# HISTORIC AND DESIGN REVIEW COMMISSION

**HDRC CASE NO:** 2024-035  
**ADDRESS:** 324 GARFIELD ST  
**LEGAL DESCRIPTION:** NCB 708 LK 8 LOT N 77.05 FT OF W 27.8 FT OF 5  
**ZONING:** RM-4, H  
**CITY COUNCIL DIST.:** 1  
**DISTRICT:** Lavaca Historic District  
**APPLICANT:** Chris Coker/BLUE LINE HOUSING LLC  
**OWNER:** Chris Coker/BLUE LINE HOUSING LLC  
**TYPE OF WORK:** Driveway installation  
**APPLICATION RECEIVED:** January 18, 2024  
**60-DAY REVIEW:** March 18, 2024  
**CASE MANAGER:** Edward Hall

## REQUEST:

Parking

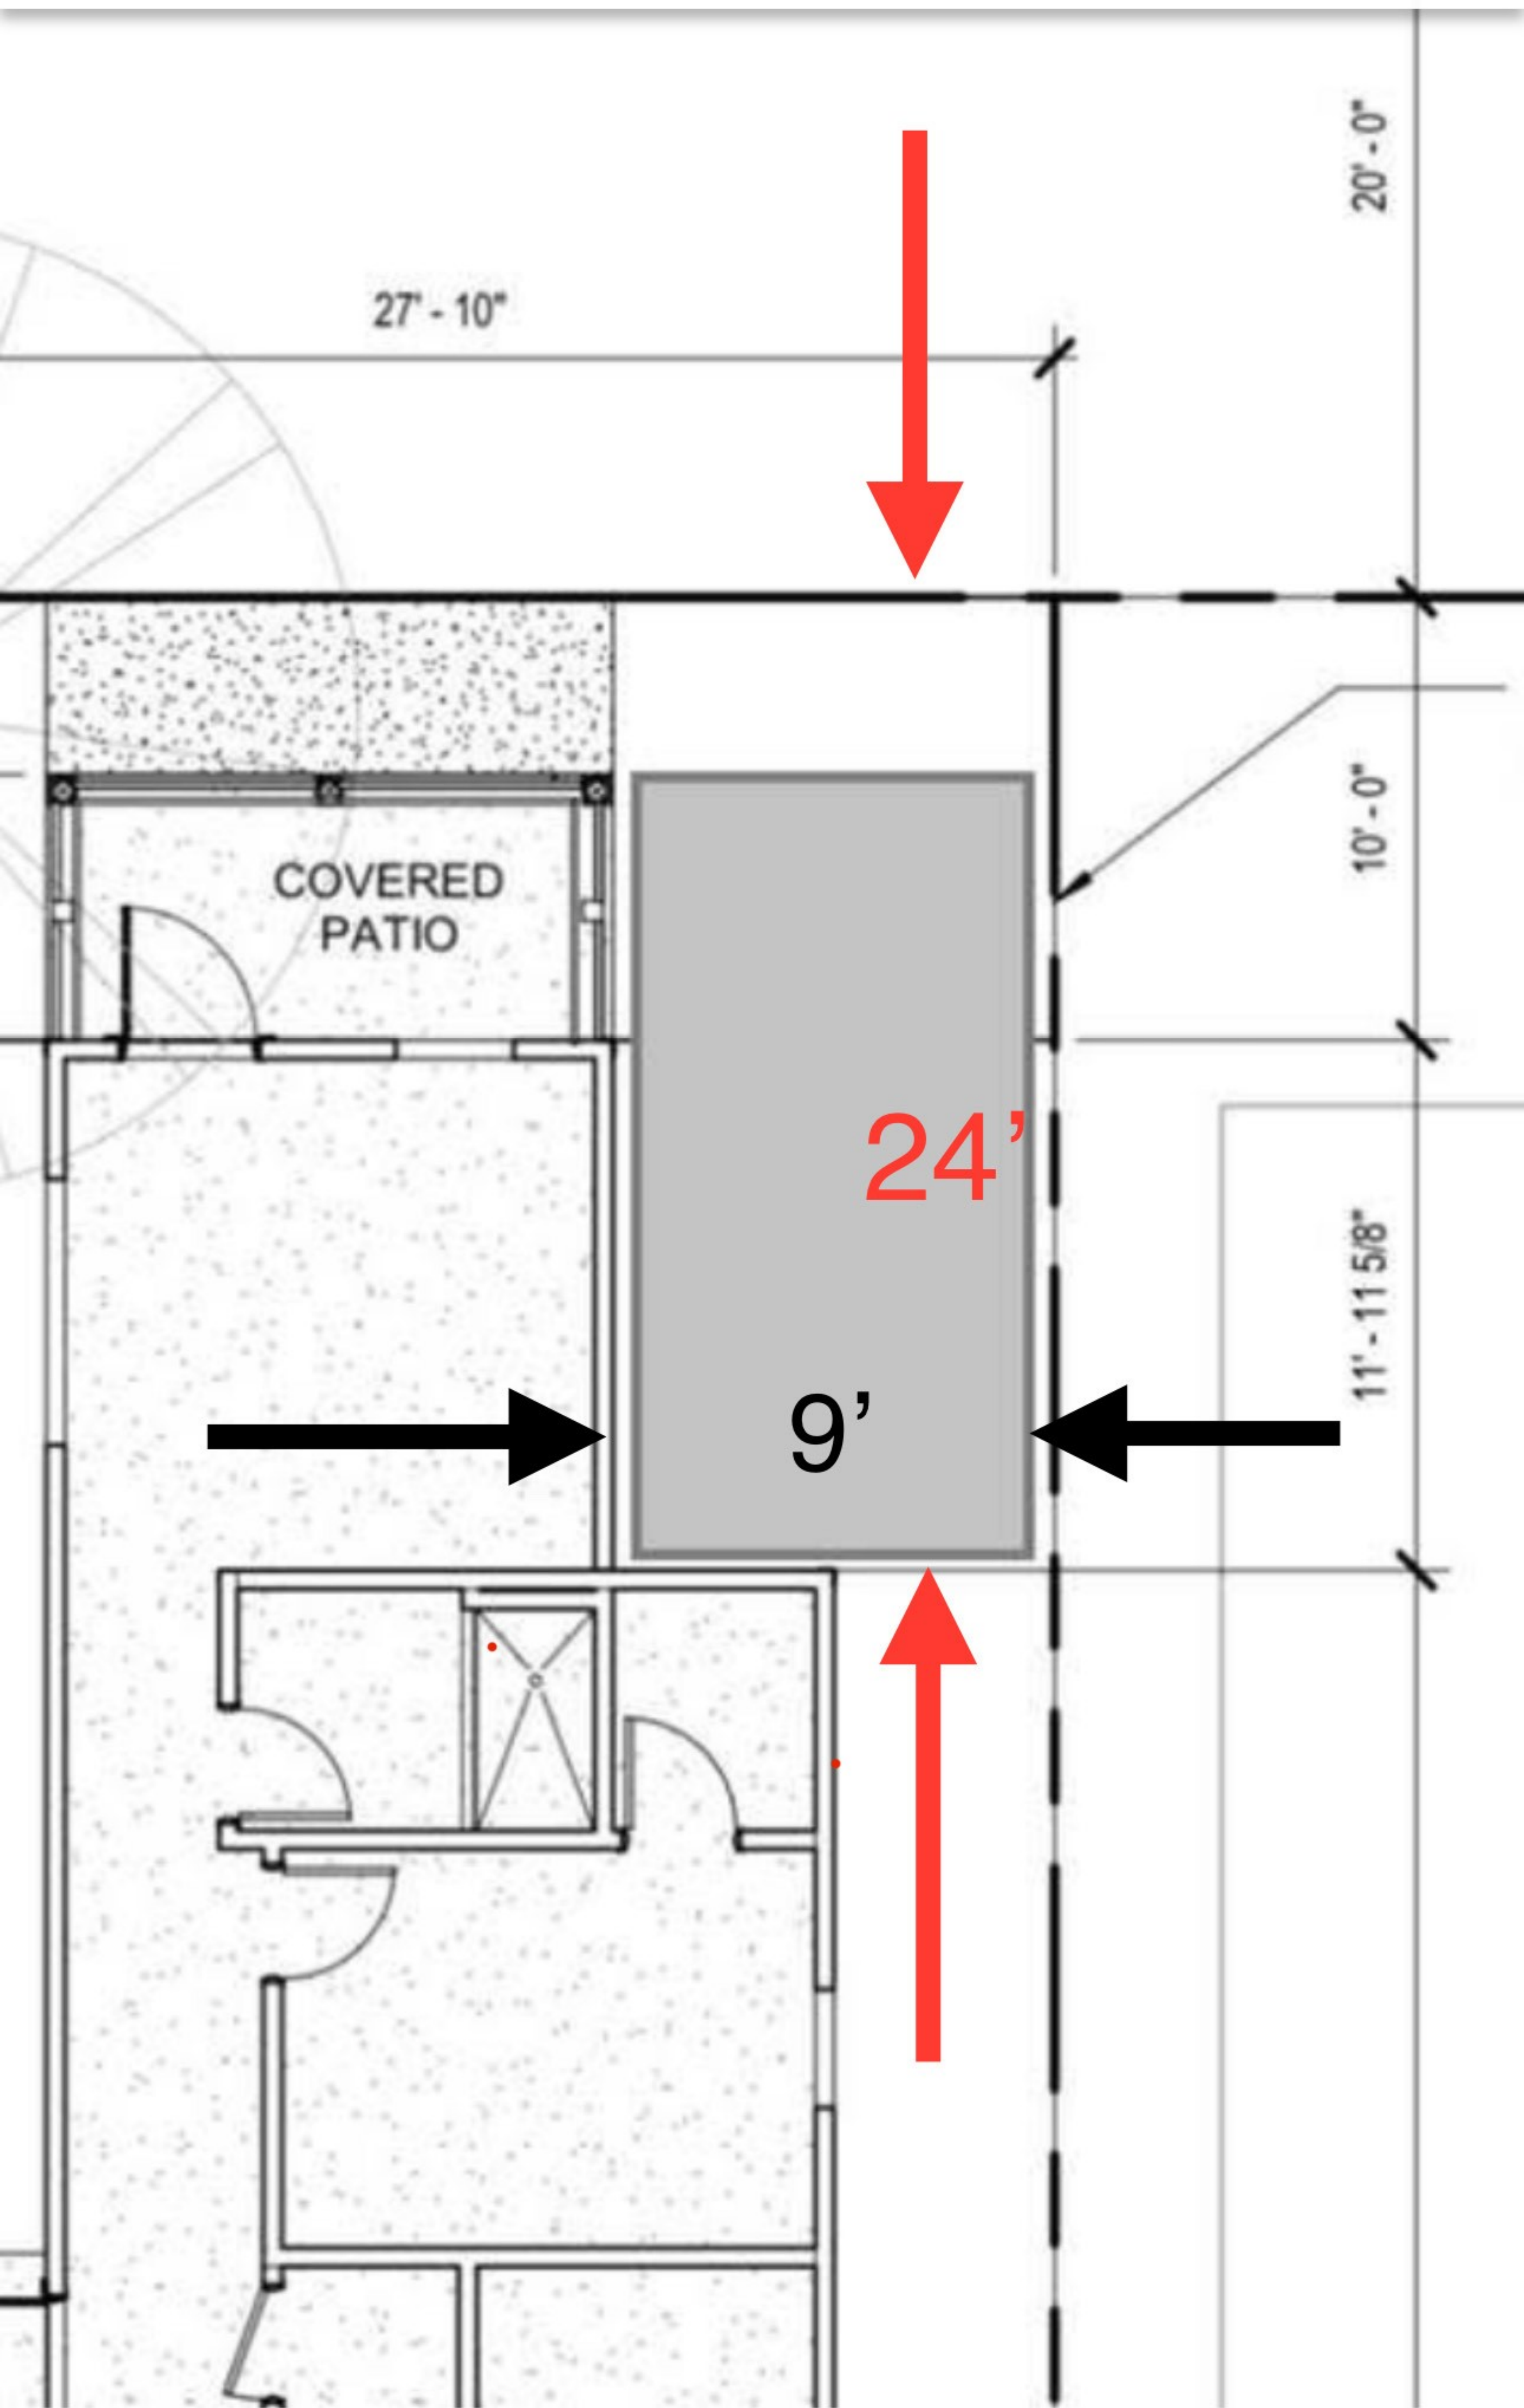
- a. The single-family residential structure at 324 Garfield Street was approved by the Historic and Design Review Commission on September 1, 2021. At the time of approval, a driveway was not proposed. The existing lot features an overall width of 27' – 10". At this time, the applicant has proposed to install a driveway on the east side of the lot. Given the width of the lot and the new construction's footprint, the driveway will run along the front massing, which includes the front porch, and terminate in front of a front facing wall. The driveway will feature a one (1) foot setback from the adjacent property line.

- b. DRIVEWAY – Per the Guidelines for Site Elements 5.B.i., new driveways are to feature a similar driveway configuration as to those found historically within the historic district regarding their materials, width and design. Generally, staff finds the propose driveway to be appropriate. Staff finds its terminus in front of a front facing wall to be appropriate given the site constraints.

- i. That a final curb cut and apron detail be submitted to staff for review and approval and that both the curb cut and apron match those currently in place on this block.
